# NOTICE OF DECISION

## PLANNING ADMINISTRATOR DECISION FOR SITE PLAN REVIEW

**CASE TYPE:** Class 2 Site Plan Review  
**AMANDA NO.:** 21-115171-RP  
**DATE OF DECISION:** January 3, 2022  
**PROPERTY LOCATION:** 3514 Commercial St SE  
**APPLICANT:** Kevin Godwin for JJS Holdings, LLC  
**ZONE:** CR (Retail Commercial)  
**COMPREHENSIVE PLAN:** Commercial  
**OVERLAY:** None

A Class 2 site plan review for a change of use from retail sales/vehicles services to solely retail sales with associated site upgrades including landscaping, new parking lot layout, and pedestrian connections for an existing building at 3514 Commercial St SE (Marion County Assessor Map and Tax Lot 083W03DB / 7300).

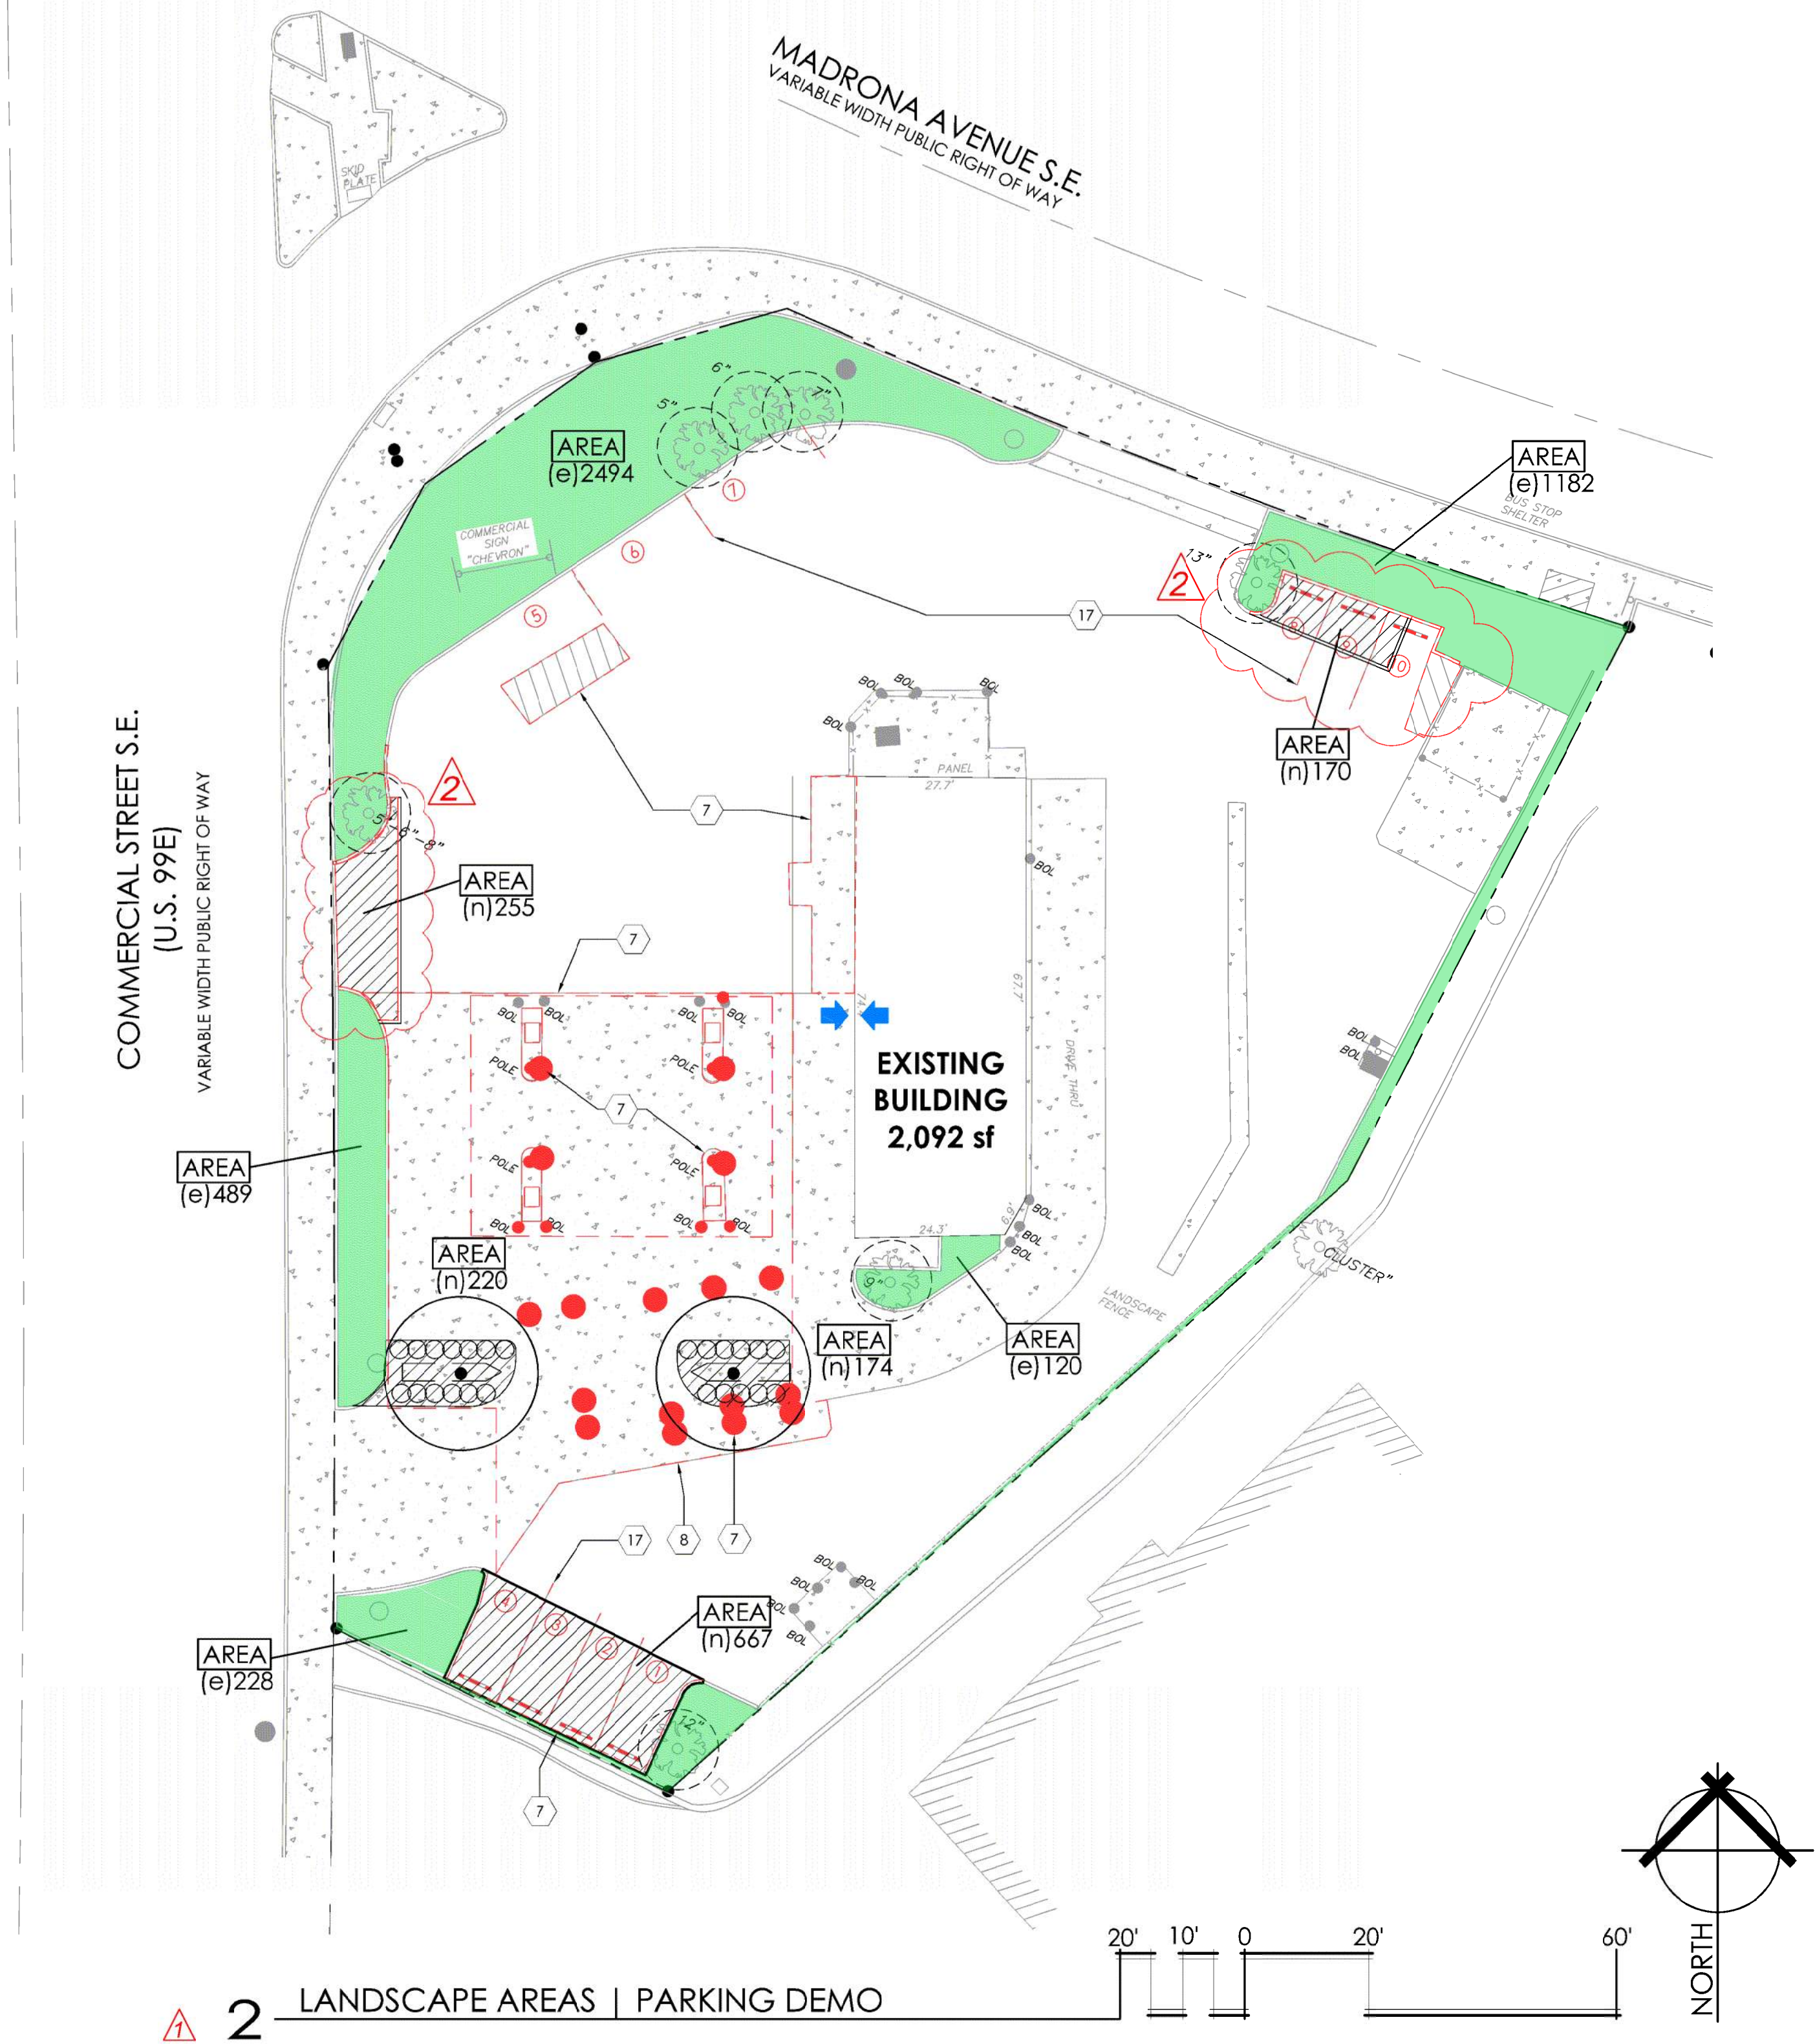
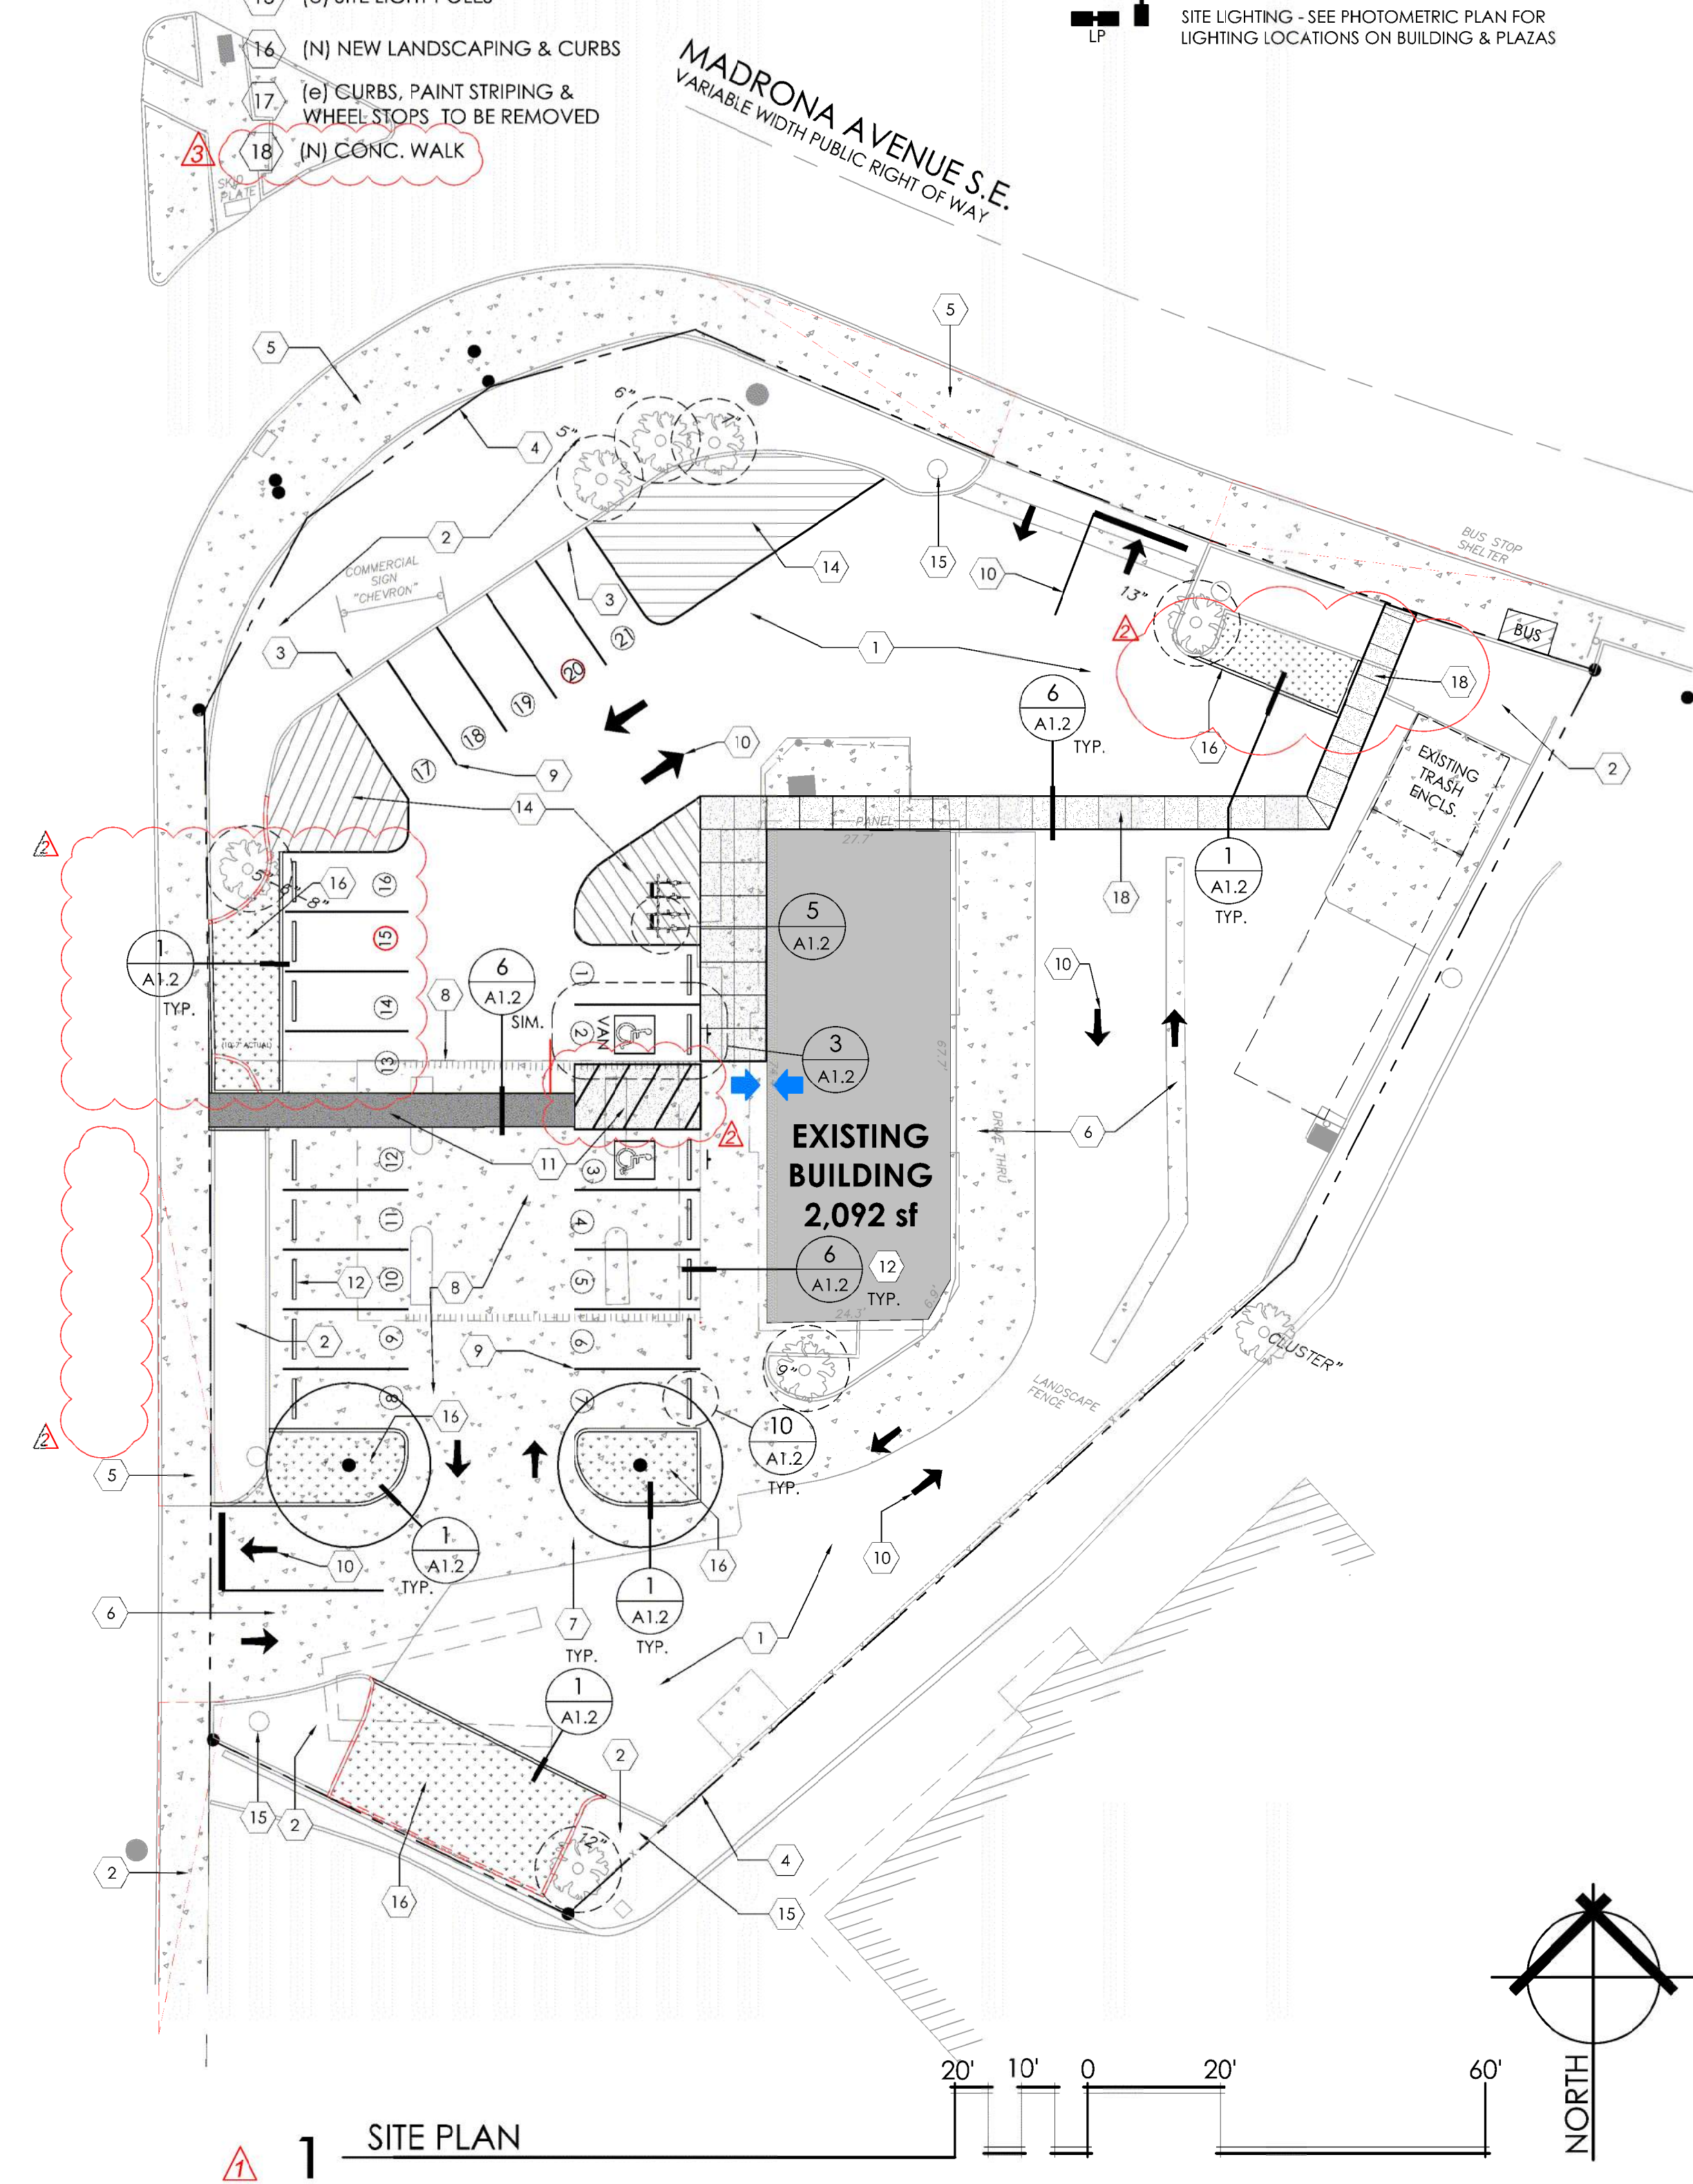
**Finding:** Pedestrian access is proposed from both Commercial St SE and Madrona Ave SE to the existing building's primary entrance. The proposal meets the standard.

**Finding:** There is an existing bus stop located along Madrona Ave SE. The applicant has proposed a new pedestrian connection that connects to the right-of-way within twenty feet of the bus stop. This standard is met.

**Finding:** The proposed site plan shows pedestrian walkways required under this chapter which meet the materials, width, and other standards of this section. The applicant has proposed a different paving material to differentiate the walkways through vehicle use areas and are a minimum of five feet in width.

**Finding:** The applicant is proposing a change of use to wholly retail sales. The ratio for retail sales is one off-street parking space per 250 sq. ft. The existing building is approximately 2,100 sq. ft., which requires a minimum of nine spaces ( $2100/250=8.5$ ). The maximum is twenty-two spaces ( $9*2.5=22$ ). The applicant has proposed a total of twenty-one parking spaces, all of which are regular sized spaces. This standard is met.

**Finding:** Where the applicant is proposing new paved areas, all of which are located adjacent to a street, there is a minimum ten-foot, landscaped setback between the property line and new parking area per Method A (SRC 806.035(c)(2)), including additional landscaping. Where parking abuts the existing building, there is a minimum five-foot paved walkway between the parking and the building, including wheel stops. The applicant has provided a tentative landscaping plan which shows the setback landscaping to Type A standard. Full compliance of the landscaping will be reviewed at the time of building permit. This standard is met.

**Finding:** The applicant's plans indicate the off-street parking area is approximately 4,000 square feet in size. Per Table 806-5, a minimum of 5 percent interior parking area landscaping is required, or 200 square feet ( $4,000 \times 0.05 = 200$ ). The off-street parking area shows approximately 400 square feet (10 percent) of interior parking area landscaping, exceeding the minimum requirement. This standard is met.

**Finding:** The proposed development has an existing building approximately 2,100 sq. ft. in size, requiring a minimum of four bicycle parking spaces. The proposed site plan shows four bicycle parking spaces. The proposal meets the standard.

**Finding:** The proposal calls for bike parking to be placed outside, less than 50 feet from the building entrances. The proposal meets the standard.

**Finding:** As shown on the proposed site plan, the proposed bicycle parking areas have direct access to the public right-of-way through the proposed pedestrian paths and the vehicle use areas. Additionally, the bicycle parking areas have direct access to primary building entrances through the proposed pedestrian pathways in conformance with the requirements of SRC 806.060(b).

**Finding:** The proposed bicycle parking spaces are located on a small paved area, with adequate dimensions to contain a total of four spaces. The spaces are adjacent to a proposed pedestrian accessway, providing a minimum 4-foot-wide access aisle. The proposal meets the standard.
